### Reply To Examiner's Remarks

Fig. 1 (Prior Art)

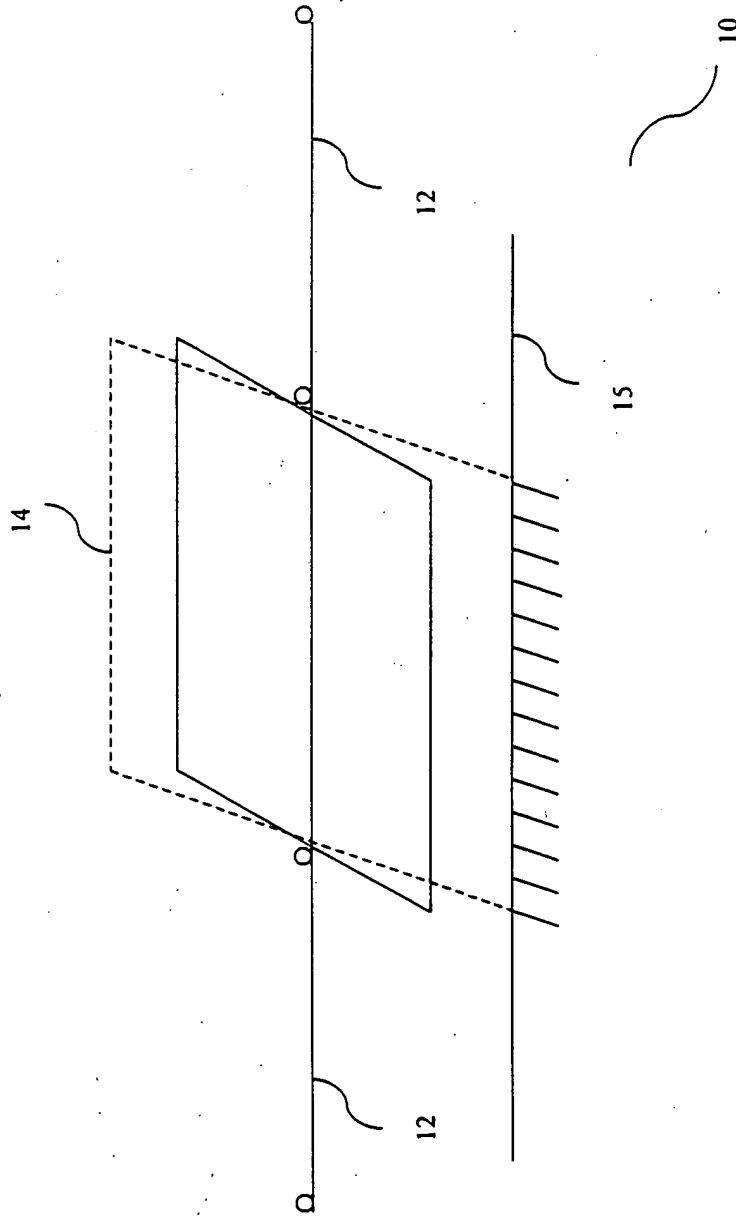
The Examiner objects to Figure 1 of the drawings, noting that this Figure should be labeled as Prior Art. An amended Figure 1, labeled as Prior Art, is submitted herein for approval by the Examiner.

Fig. 6

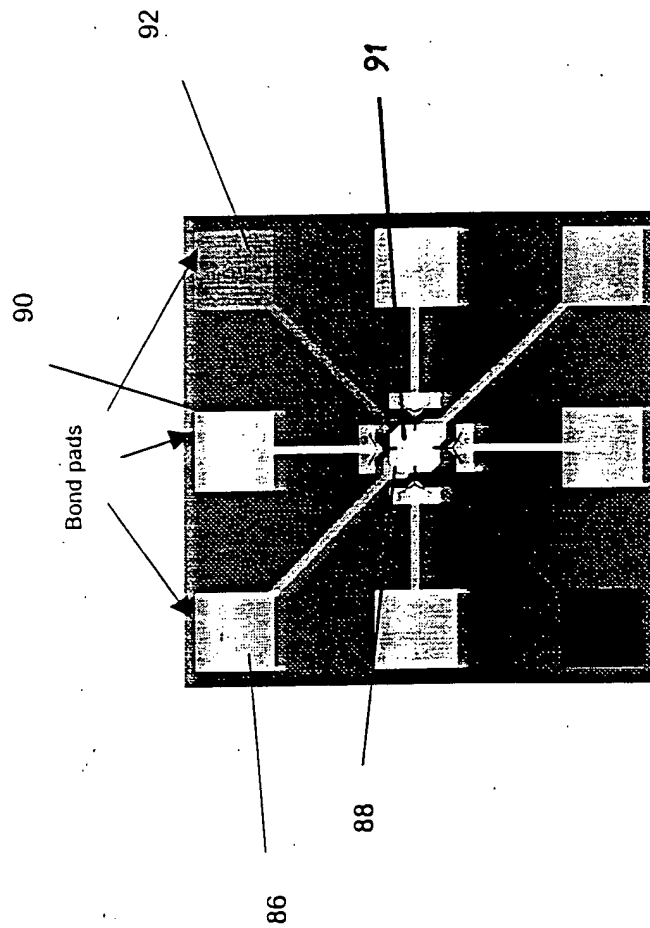
The Examiner objects to an unspecified drawing, believed to be Figure 6, noting the driving electrode 91 is not explicitly shown in this Figure. An amended Figure 6, labeling the driving electrode 91, is submitted herein for approval by the Examiner.
